Prairie Island Nuclear Generating Plant Units 1 and 2
Dockets 50-282 and 50-306
License Nos. DPR-42 and DPR-60

Response to Requests for Additional Information RE: License Amendment Request to Adopt the Alternative Source Term Methodology (TAC Nos. ME2609 and ME2610)

NRC RAI - AADB RAI 9

**Figure 2
(Revised Figure 3.6-1)
MSLB Analytical Model**

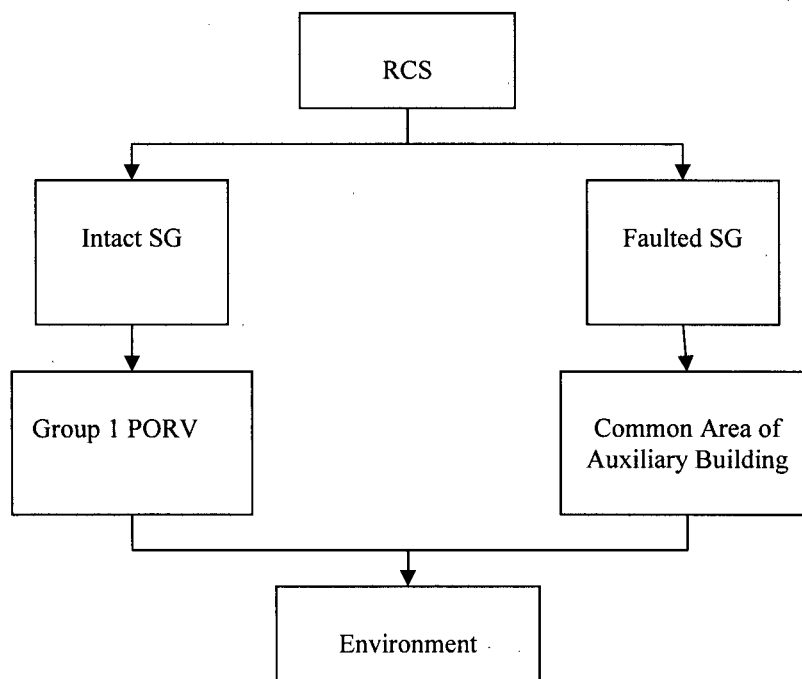
Section 3.6.2 of the enclosure to the LAR provides a schematic of the analytical model used in the MSLB analysis. Figure 2 provides a revised schematic of the analytical model and supersedes Figure 3.6-1 in the enclosure to the LAR (the change is the TDAFWP Steam Exhaust is deleted as a release path from the Intact SG).

Section 3.6.4 of the enclosure to the LAR discusses the radiological release paths modeled in the analysis. The radiological release path for the faulted SG is not changed. The radiological release path for the intact SG is changed to delete the TDAFW Steam Exhaust as a release path. With this change, the total steam mass release shown in Table 3.6-2 is through the Group 1 PORV. Table 4 shows the steam mass release through the PORV and supersedes Table 3.6-2 in the enclosure to the LAR.

**Figure 3
(Revised Figure 3.7-1)
SGTR Analytical Model**

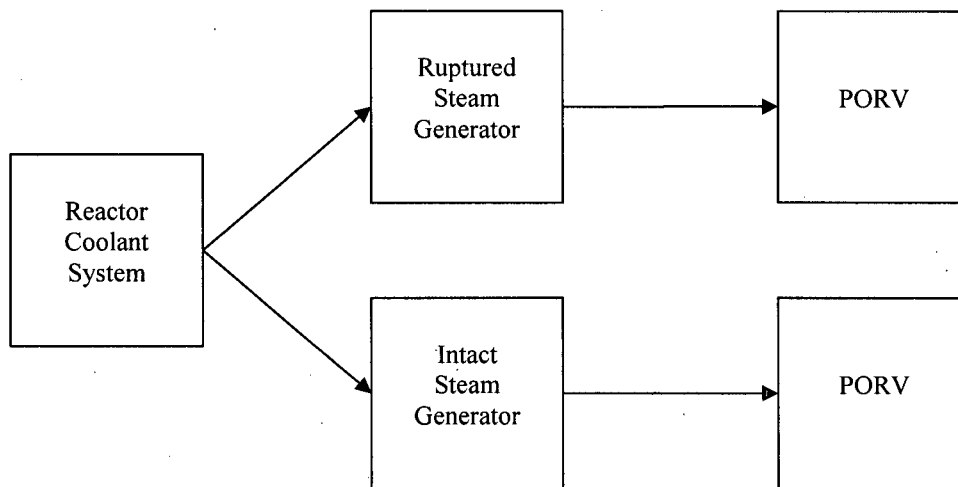
Section 3.7.2 of the enclosure to the LAR provides a schematic of the analytical model used in the SGTR analysis. Figure 3 provides a revised schematic of the analytical model and supersedes Figure 3.7-1 in the enclosure to the LAR (the change is the TDAFWP Steam Exhaust is deleted as a release path from the Steam Generators).

Section 3.7.4 of the enclosure to the LAR discusses the radiological release paths modeled in the analysis. Consistent with the change to the analytical model depicted by the above figure, the radiological release path for the faulted SG and the intact SG is changed to delete the TDAFW Steam Exhaust as a release path. Table 7 summarizes the steam mass release points following a SGTR and supersedes Table 3.7-2 in the enclosure to the LAR.

Figure 4
(Revised Figure 3.8-1)
CREA Analytical Model

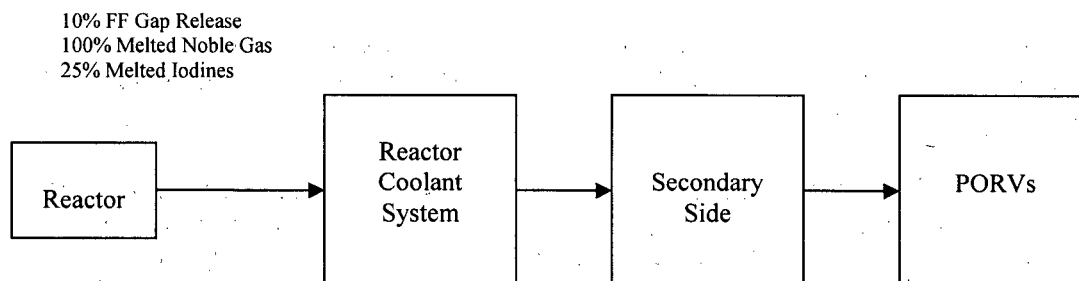
Section 3.8.2 of the enclosure to the LAR provides a schematic of the analytical model used in the CREA analysis. Figure 4 provides a revised schematic of the analytical model and supersedes the Steam Generator Release Path shown in Figure 3.8-1 in the enclosure of the LAR (the change is the TDAFWP Steam Exhaust is deleted as a release path from the Steam Generators).

Section 3.8.4.2 of the enclosure to the LAR discusses the radiological release paths modeled in the analysis. The radiological release path for the SG is changed to delete the TDAFW Steam Exhaust as a release path. With this change, the total steam mass release shown in Table 3.8-5 is through the PORVs. This is shown in Table 12; which supersedes Table 3.8-5.

**Figure 5
(Revised Figure 3.9-1)
LRA Analytical Model**

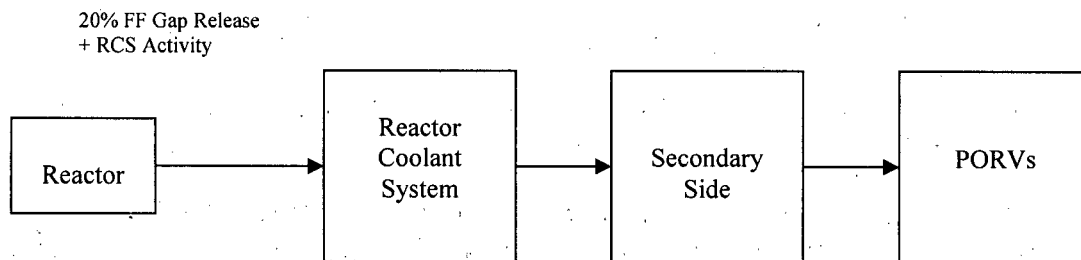
Section 3.9.2 of the enclosure to the LAR provides a schematic of the analytical model used in the LRA analysis. Figure 5 provides a revised schematic of the analytical model and supersedes Figure 3.9-1 in the enclosure to the LAR (the change is the TDAFWP Steam Exhaust is deleted as a release path from the Steam Generators):

As described in Section 3.9.4 of the enclosure to the LAR, the radiological release paths modeled in the analysis are the same as the steam release paths described for the CREA analysis. This is also the case with the revised analysis. Thus, the steam mass releases and average X/Q values for the revised LRA analysis are the same as those described above for the CREA.
